SFD26836

PLOT PLAN

LOT 122 ✓
The Sanctuary Filing No. 1 at Meridian Ranch ✓
EL PASO COUNTY, COLORADO

13795 NEDERLAND DRIVE ✓

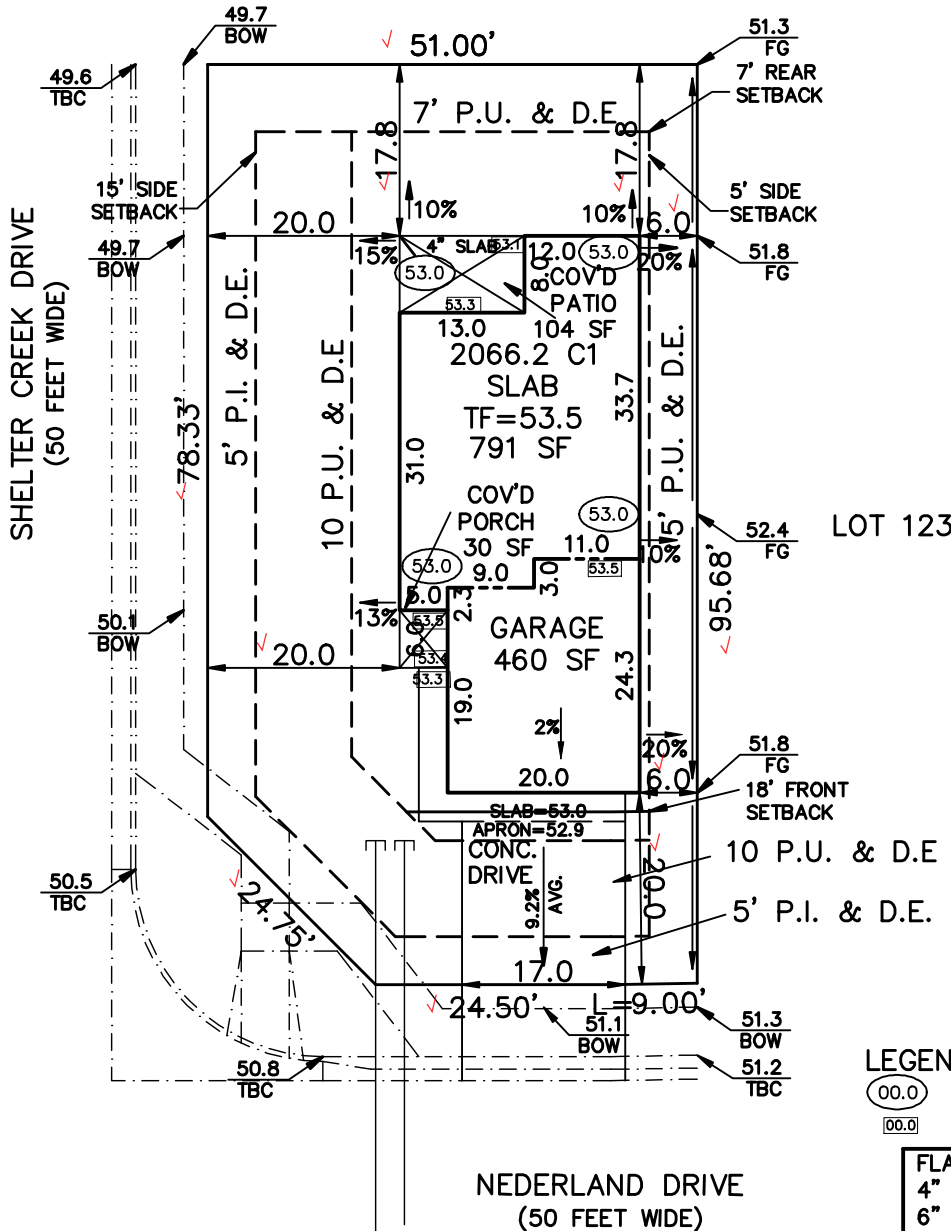
APPROVED
Plan Review
10/26/2026 3:25:33 PM
dsdyounger
EPC Planning & Community
Development Department

This parcel is in a low/moderate/high intensity fire
risk area. Please reach out to the local fire district
regarding recommendations for compliance with the
WRC code.
It is the owner's responsibility to
coordinate with easement holders
to avoid impact to utilities that
may be located in the easements.
